**Addendum #6**

***A D D E N D U M N O . : 0 5***

<b>Project Name:</b>	Metropolitan Library
<b>Project Number:</b>	11165
<hr/>	
Date:	24 June 2004
To:	Evan Jahn - Heery/Russell; Jeff Lewis, William Mensah - Winter-Construction
From:	Sara Singleton, SDA
Copies:	Robyn Zurfluh, Craig Wertz, Glenn Grosse - SDA

This addendum forms a part of the Contract Documents and modifies the original "Revised Pricing Documents" dated 05/28/14.

**C** CONCRETE UNIT PAVERS - VEHICULAR  
 3/4" = 1' 0"

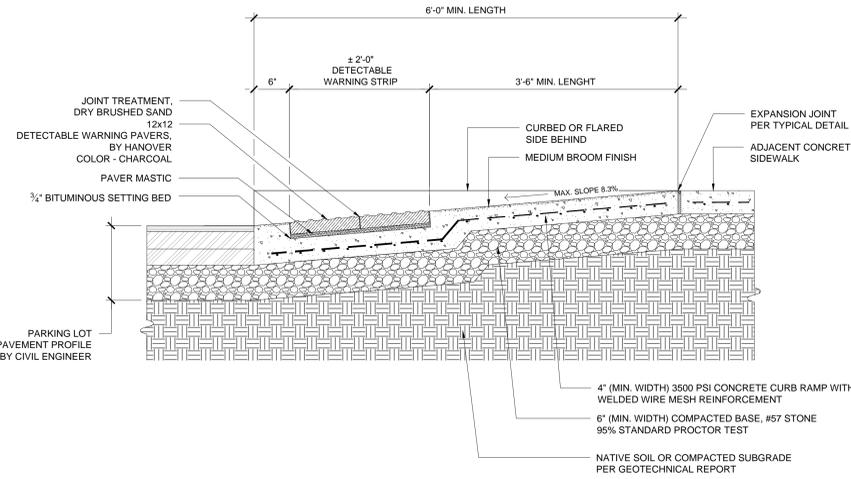
1. Concrete Unit Pavers (Parking lot drop off): The pavers will be on a concrete base with bituminous setting bed. See detail C on L500 attached. Also see manufacturer specification sheet attached (Hanover).

SHEET NO: **ASD 09**

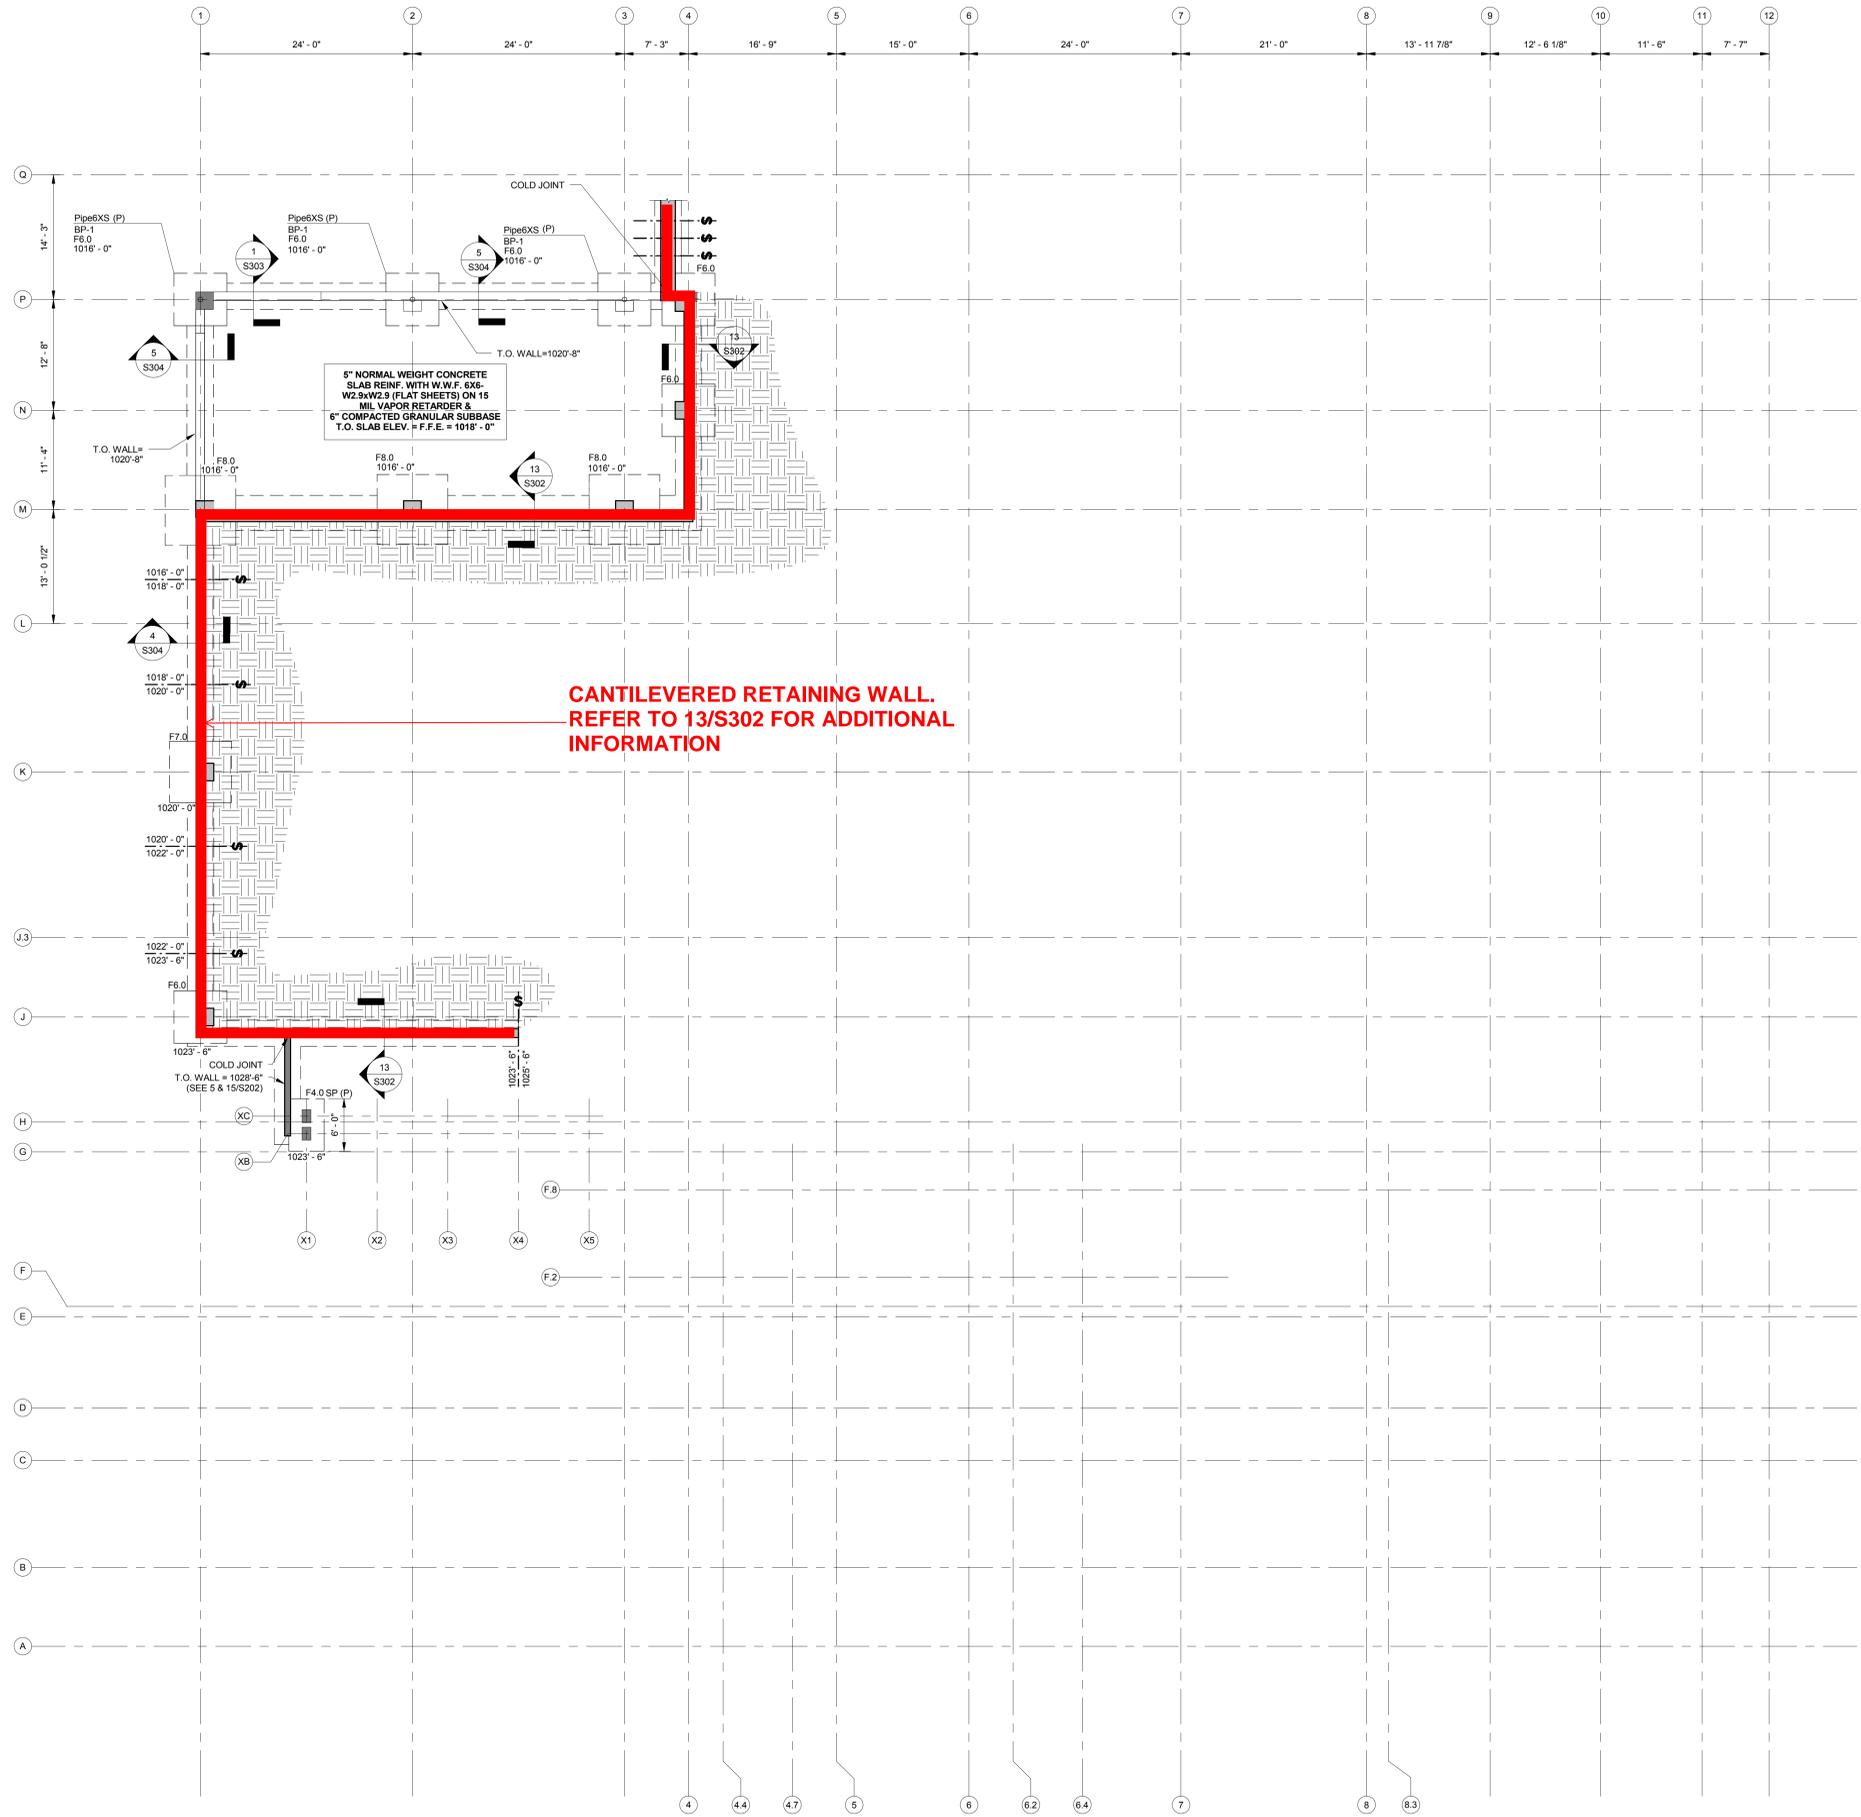
1. To clarify extent of concrete curb at perimeter of building, see ASD #9 attached. See 3/A500 for top of wall condition.

1. Refer to ASD #9 and corresponding description above for clarification on extent of concrete curb at perimeter of building. Details 7 & 8/S203 to include concrete curb.
2. S111 Revised: Grade Beam locations are typically at the brace locations and are denoted as GB-1 on Foundation Plan (revised) S111 attached.
3. S110 Revised: See revised plan attached for clarification of cantilevered retaining wall extent.

E001

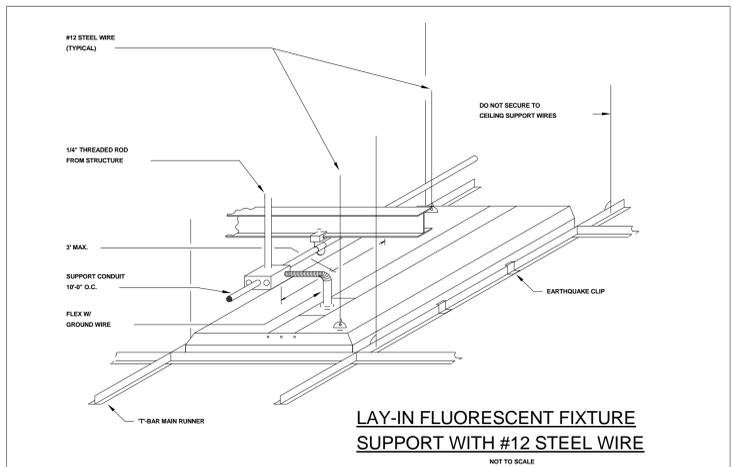
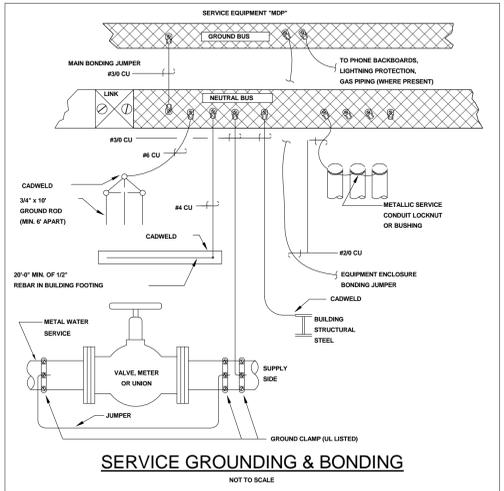
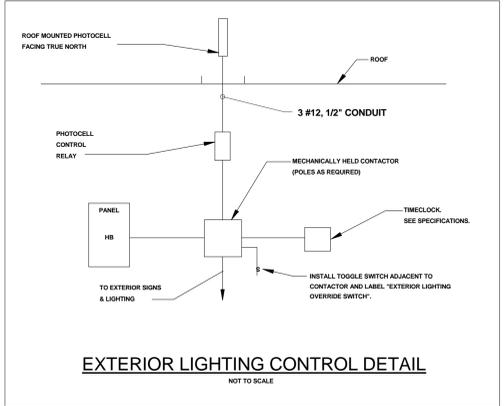
1. E001 & E201: Lighting fixture schedule and plan have been updated. See revised sheets attached. Also on E001 the Electronic symbol legend has been updated to include the floor box and distribution unit for under floor cabling.
